## Product Change Notification

**PCN No:** 2021-04-16-01  
**Report Date:** April 16, 2021  
**Subject:** HTT70A-TPN Display Change  
HTT70G-TPC Display Change  
HTT70A-TPR Display Change  
HTT70A-TPC Display Change

New 7.0" TPN display

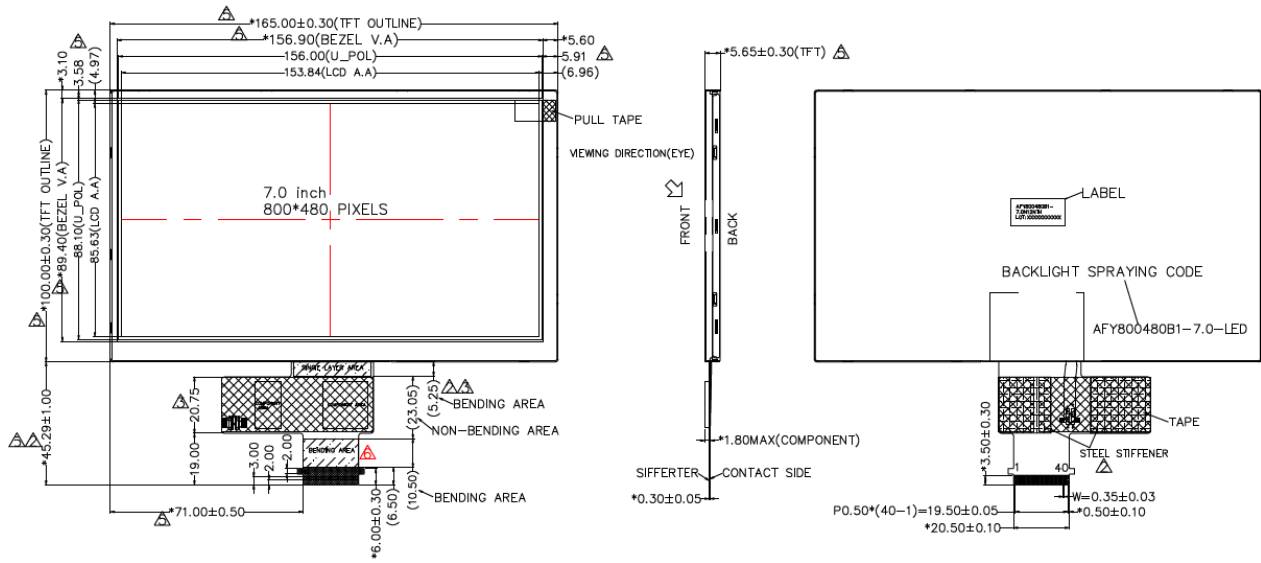
The display mechanically has become thicker with minimal module mechanical change.

Current	New
Module size (L*W*H) mm	TPN: 164.9 * 100.0 * 3.5 TPR: 164.9 * 100.0 * 4.7 G-TPC: 179.9 * 119.0 * 5.8	TPN: 165.0 * 100.0 * 5.6 TPR: 165.0 * 100.0 * 6.9 G-TPC: 179.9 * 119.0 * 7.9
Active area (L*W)	153.84 * 85.63	153.84 * 85.63
Pixel pitch (L*W)	0.192 * 0.178	0.192 * 0.178
